PLANNING RESPONSES
SUNLIGHT HOUSE
APRIL 2023

EXTERNAL ALTERATIONS

INTERNAL ALTERATIONS

25. LEVEL 14 PLANT ROOM

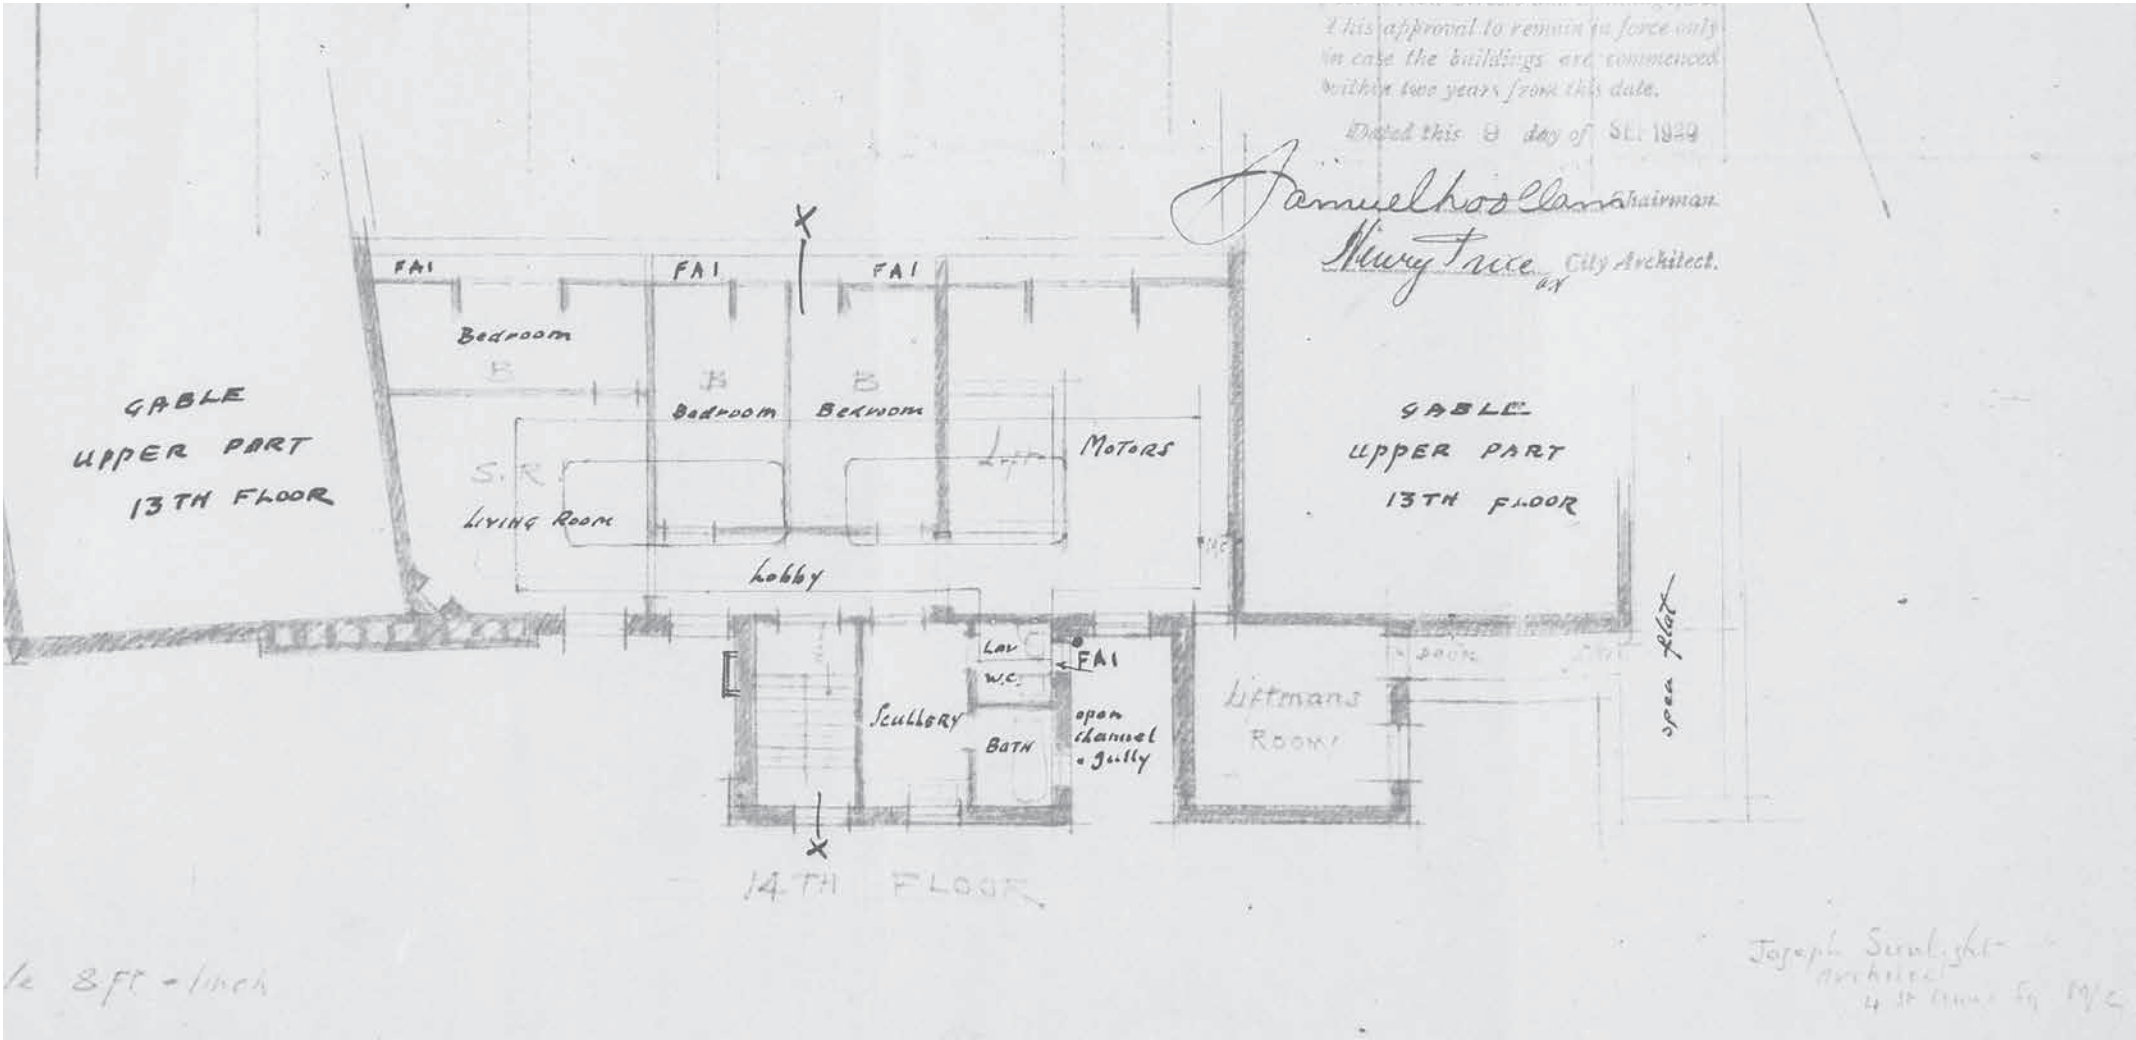
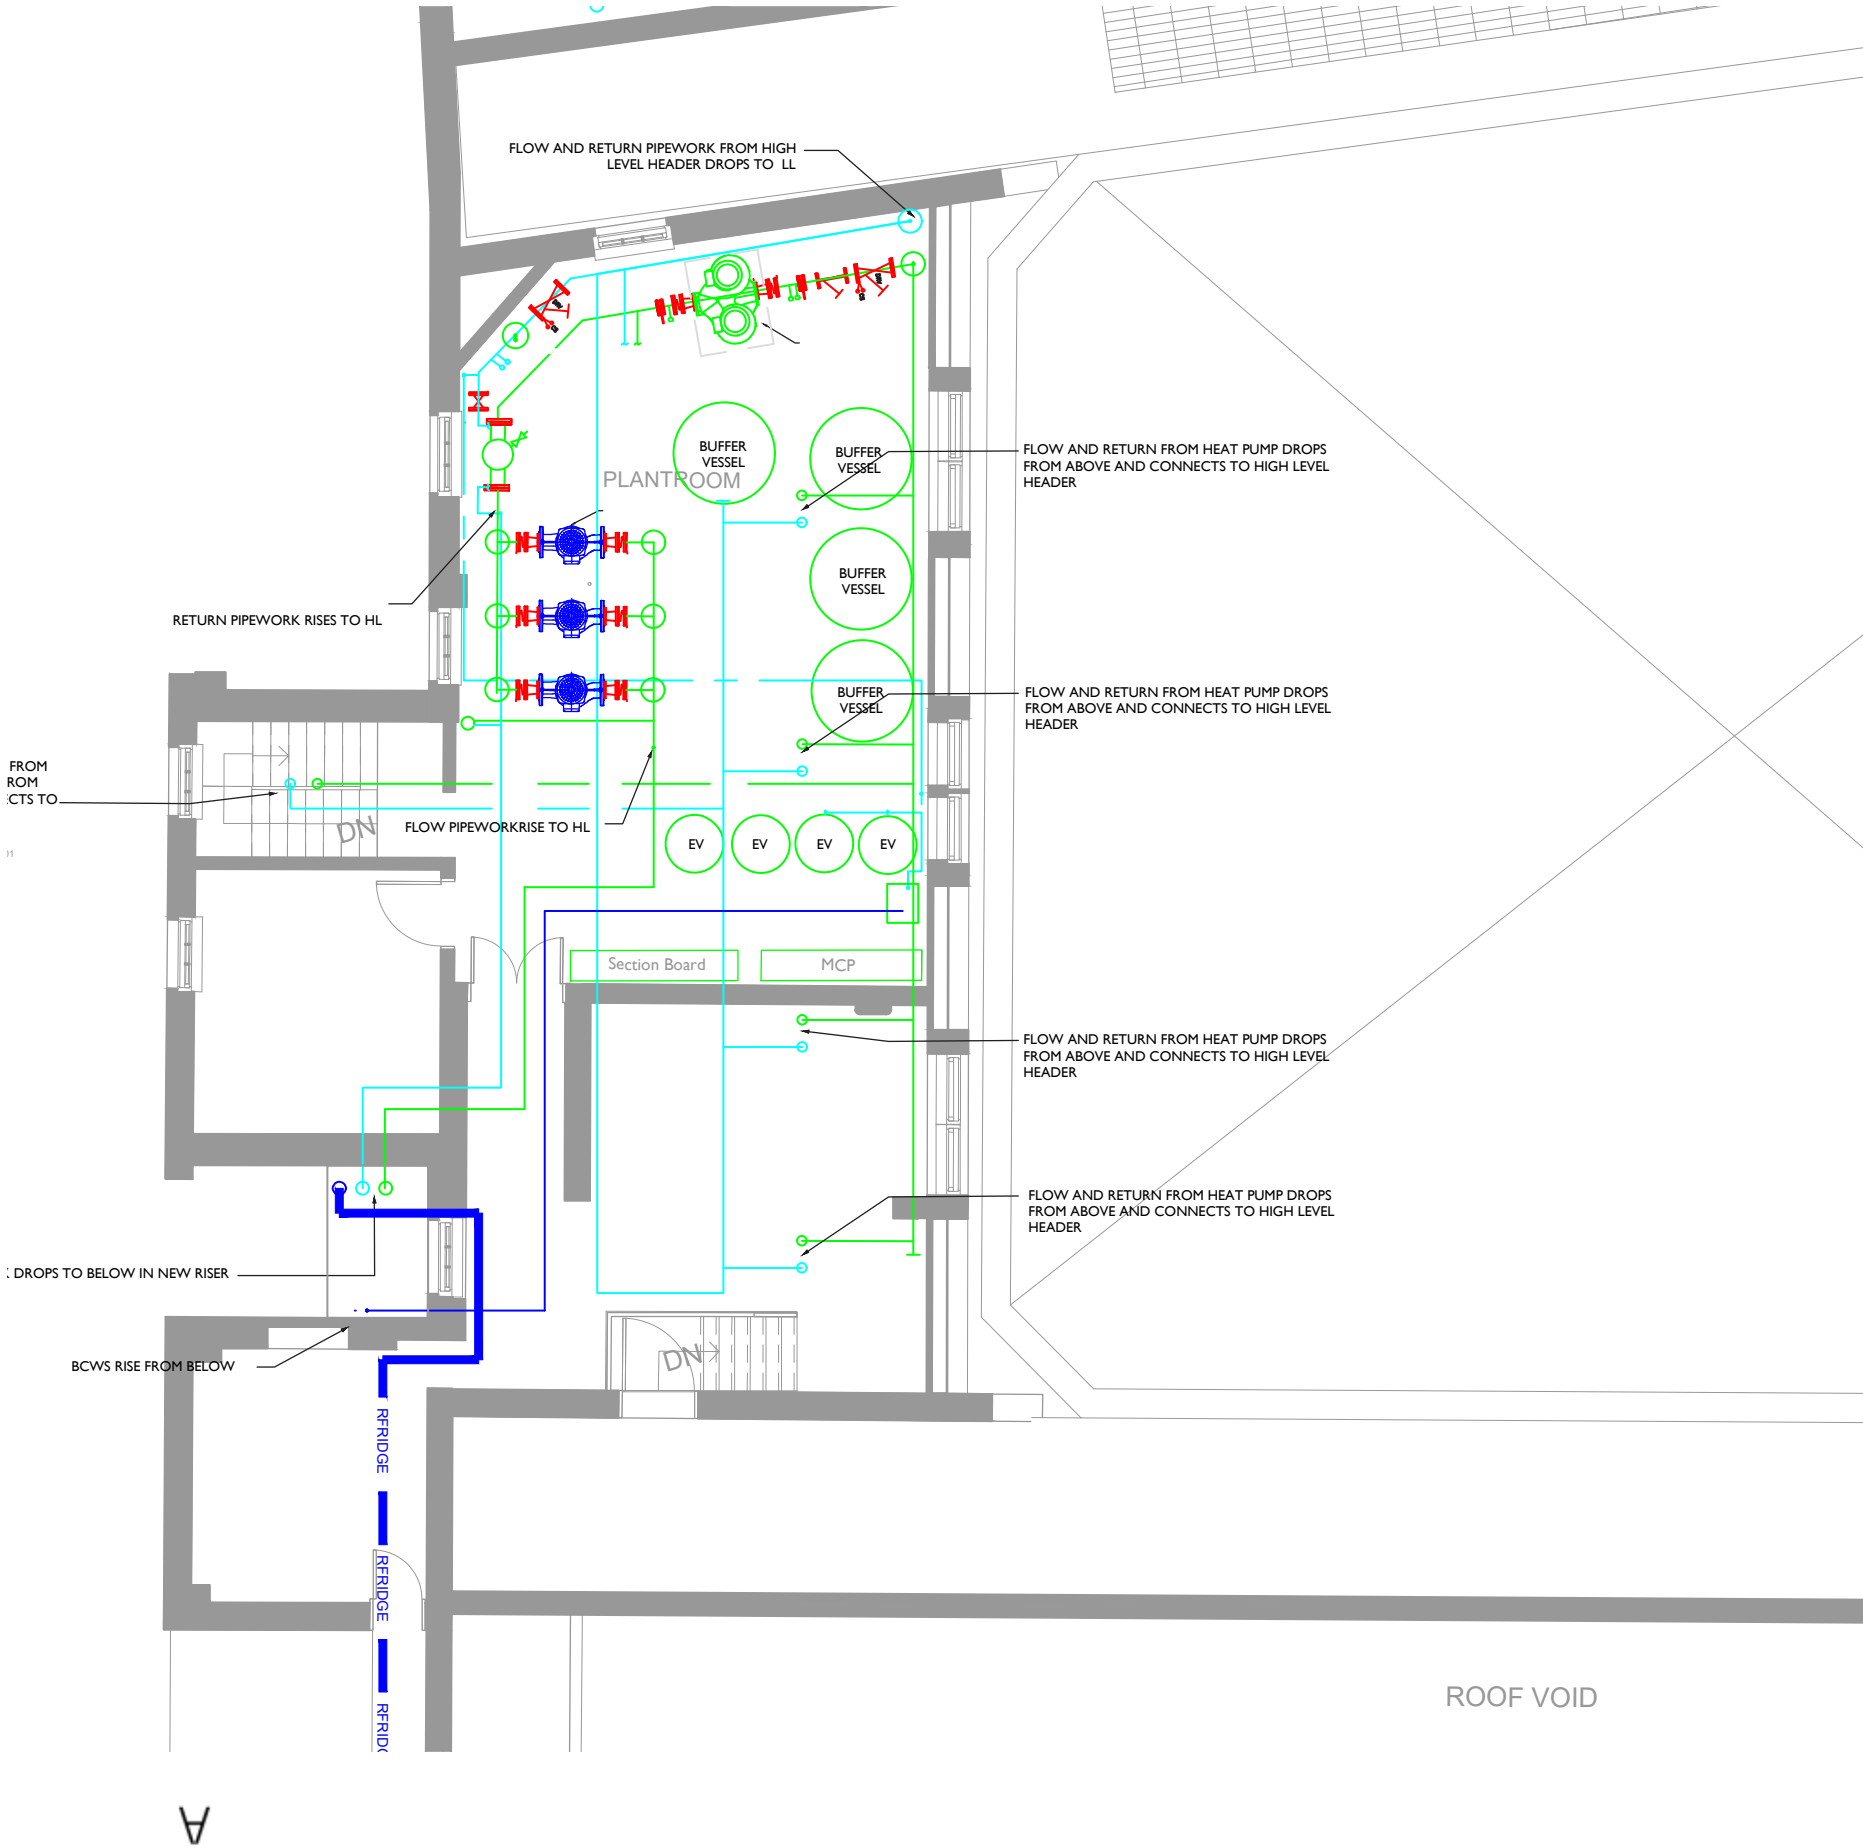
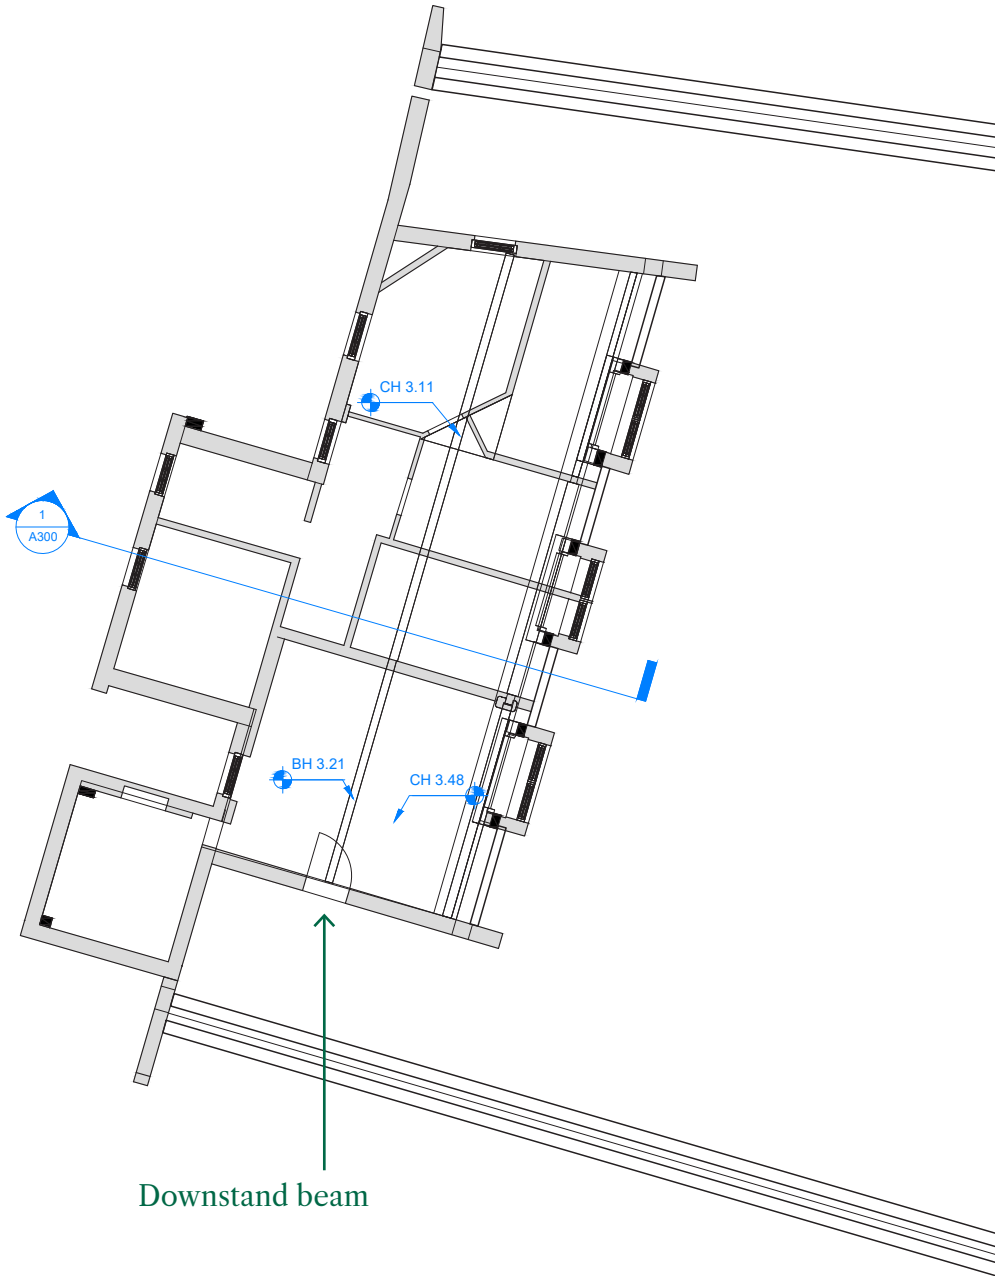
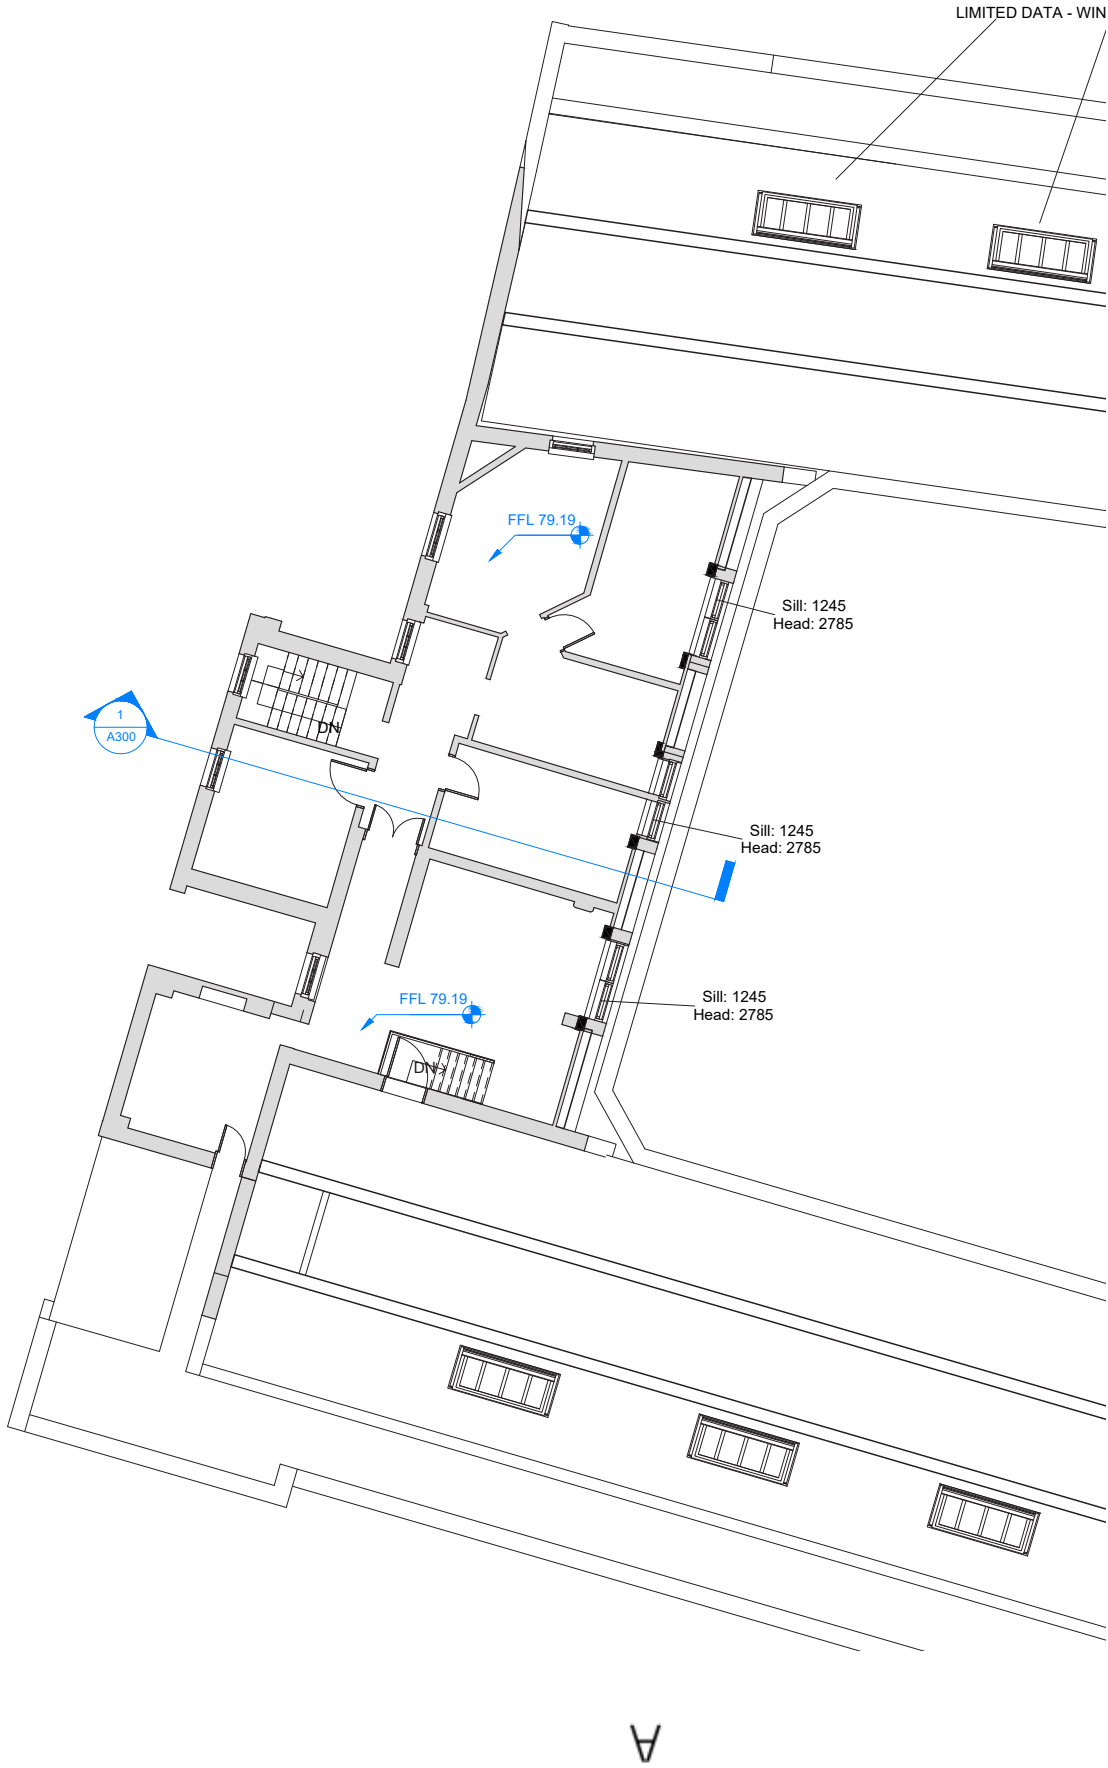
There is a dispute about the extent of original features in this space with elements of original floorplan, cornicing, window surrounds, parquet floor and white glazed tiles all evident in this space. Indeed, the photograph show the parquet floor largely intact. It is accepted that most of the partitions are modern but reflect the original subdivision. To that end the removal of the partitions would cause a degree of harm. Did you undertake a options analysis to look at alternative locations of the plant before deciding of this area? We would like to explore with you whether more of the original layout could be retained including partitions and repair and reinstatement of features such as the floor, ceilings, stairs, metal work and handrails.

The challenge we face in this area is the balance between access, maintenance and heritage. We discussed on site that this area was weighed up against the level 13 space as potential on site plant space, with this area deemed more appropriate due to its condition, inaccessibility and already housing significant lift and heating plant in the area.

In this diagram, the scale and size of proposed equipment is visible. Maintaining the small doorways and non original wall presents a problem for installation and maintenance of this kit.

Note on the facing RCP survey the misalignment between the downstand beam and the wall layout.

Original partitions (in dashed pink line) will be retained as downstands. Original ceiling will be repaired. Protective flooring cover will be included over existing heritage floor finish.
